Project	IEEE 802.16 Broadband Wireless Access Working Group < http://ieee802.org/16 >	
Title	IP re-establishment Optimization (HO&Forwarding)	
Date Submitted	2004-06-20	
Source(s)	Ronny (Yong-Ho) Kim LG Electronics, Inc. 533, Hogye-1dong, Dongan-gu, Anyang-shi, Kyongki-do, Korea	Voice: 82-31-450-4387 Fax: 82-31-450-7912 mailto: ronnykim@lge.com
Re:	Response to HO Ad-Hoc Call for Contributions on IEEE 80.16e/D3	
Abstract	IP re-establishment Optimization	
Purpose	Provide mechanism to optimize IP re-establishment handover when MSS is in receiving data or when MSS is not receiving data.	
Notice	This document has been prepared to assist IEEE 802.16. It is offered as a basis for discussion and is not binding on the contributing individual(s) or organization(s). The material in this document is subject to change in form and content after further study. The contributor(s) reserve(s) the right to add, amend or withdraw material contained herein.

IP re-establishment Optimization

Ronny (Yong-Ho) Kim
LG Electronics

Figure 1. Data forwarding vs IP address re-establishment

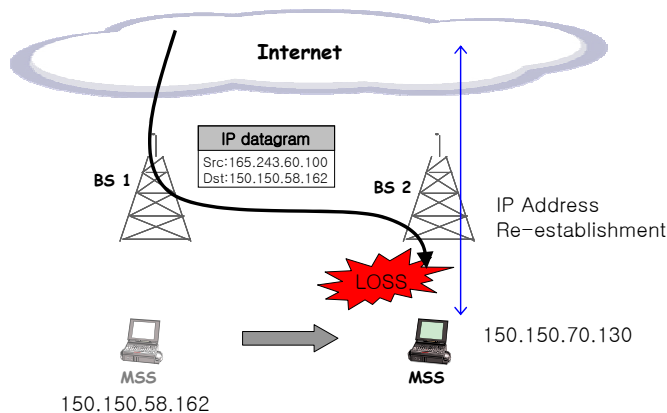
When handover is performed, the serving BS may either discard MAC SDUs associated with the MSS or forward MAC SDUs for service continuation. However in case of data forwarding, if the MSS re-establishes IP connectivity after handover, forwarded data are useless due to IP address change.

Therefore, it is required for MSS to defer IP re-establishment if there are forwarded data from the serving BS.
